ADDENDUM N0. 1

HERNDON STATION METRO GARAGE
CONTRACT NO.CN16100006
PROJECT NO. TF-000020-001

This addendum is supplementary to the contract documents for the Herndon Station Metro Garage in Herndon, Virginia.

1 P1 LEVEL SUPPORT SPACES
1/4" = 1'-0"

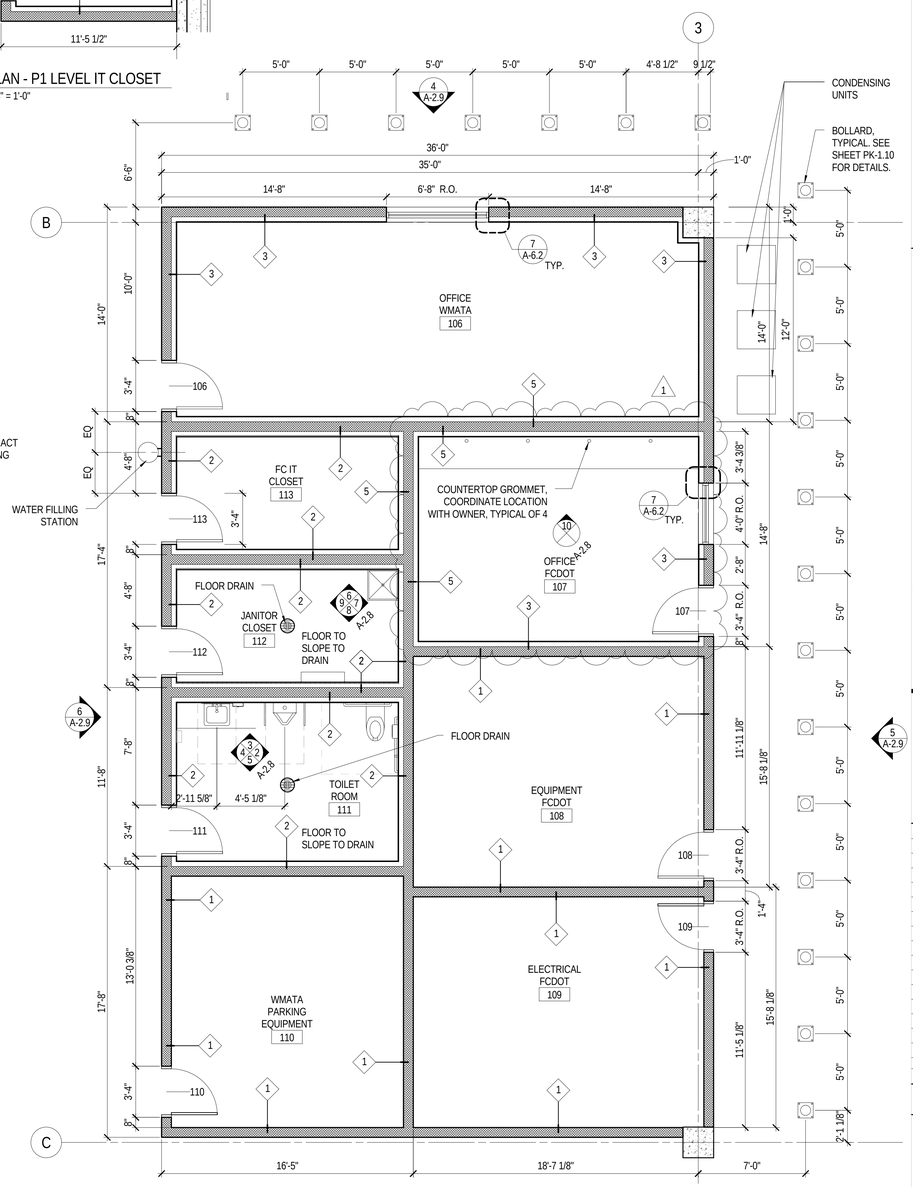
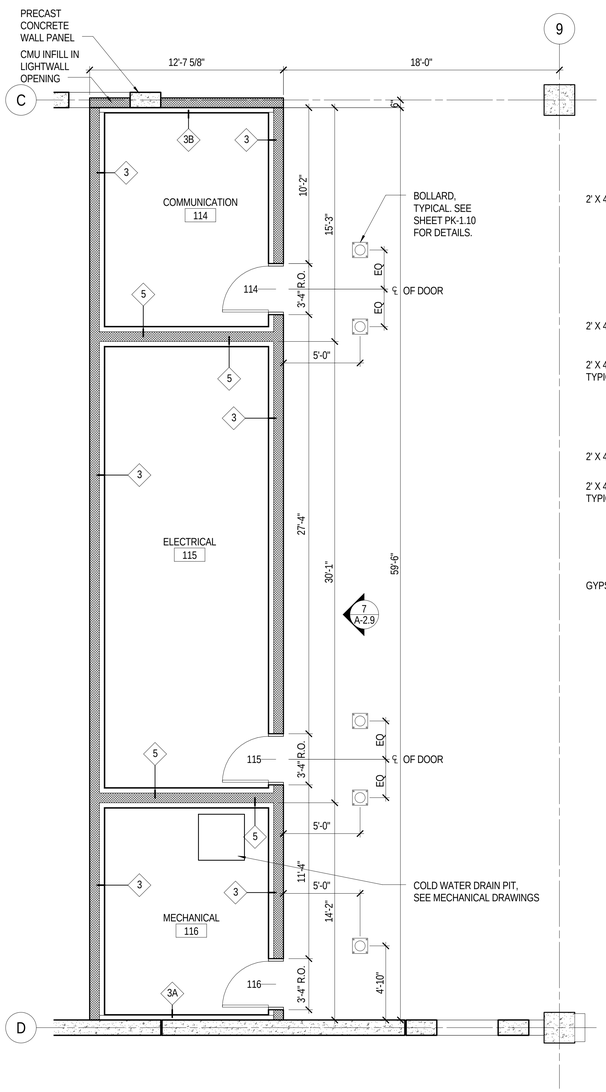
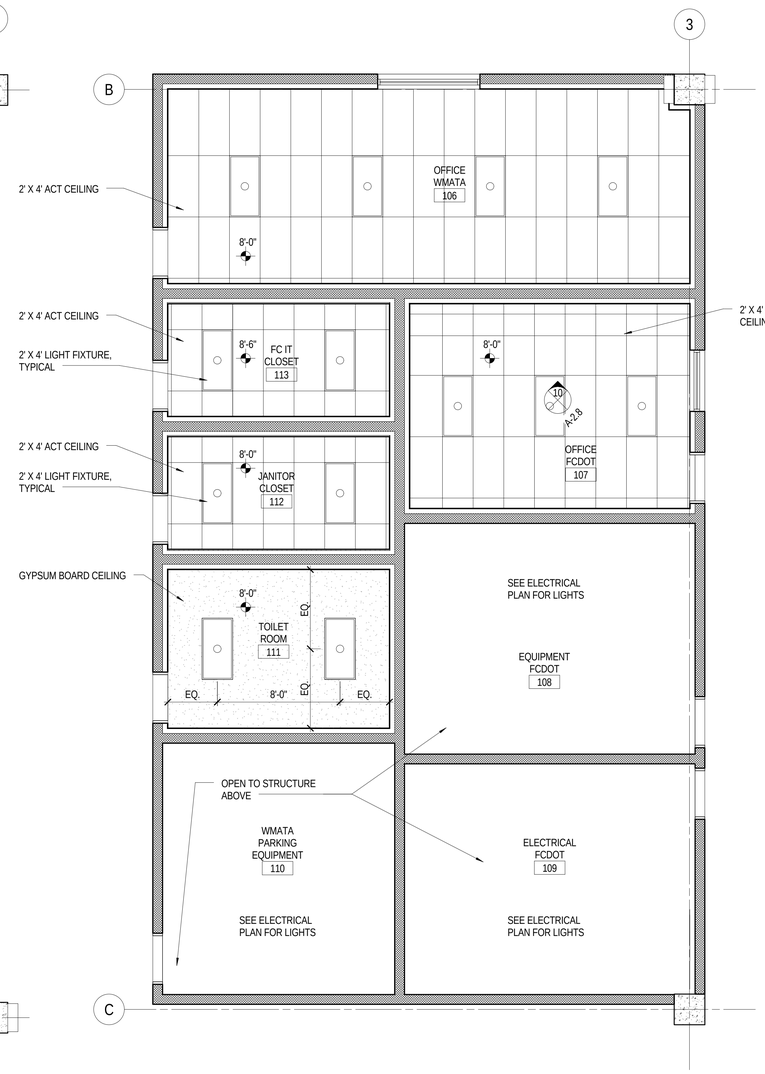
1.9	A-2.8	Added millwork details 10 and 11.
1.10	A-4.7	Added millwork counter to room 107 FCDOT Office.
1.11	PK-2.01	Revised demo note to refer to SD sheets. Note revised in two locations.

FOUNDATION PLAN

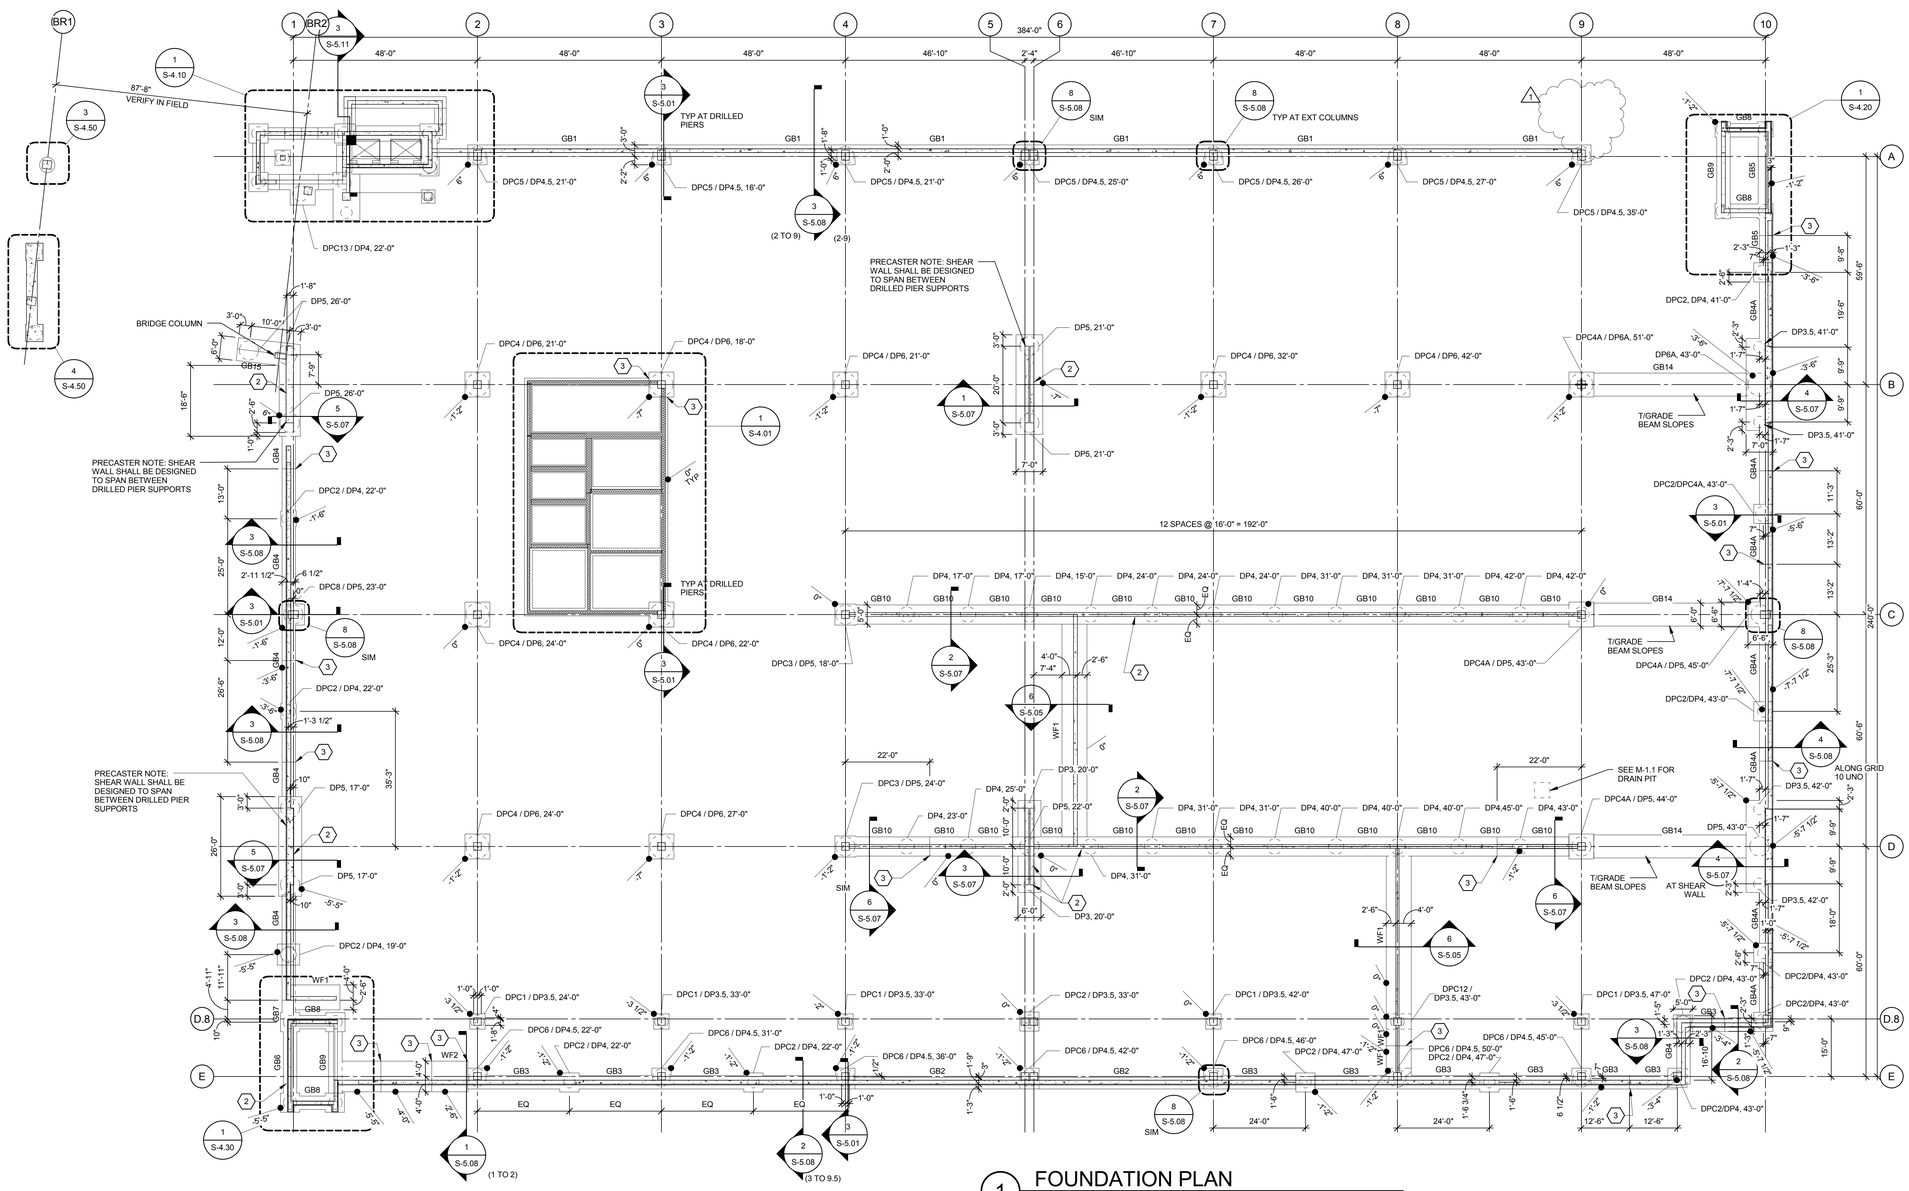
1.12	S-1.00	Removed external CIP retaining wall north of Grid A/9.
1.13	S-1.10	Removed external CIP retaining wall north of Grid A/9.
1.14	E-4.10	Removed references to emergency phone system.
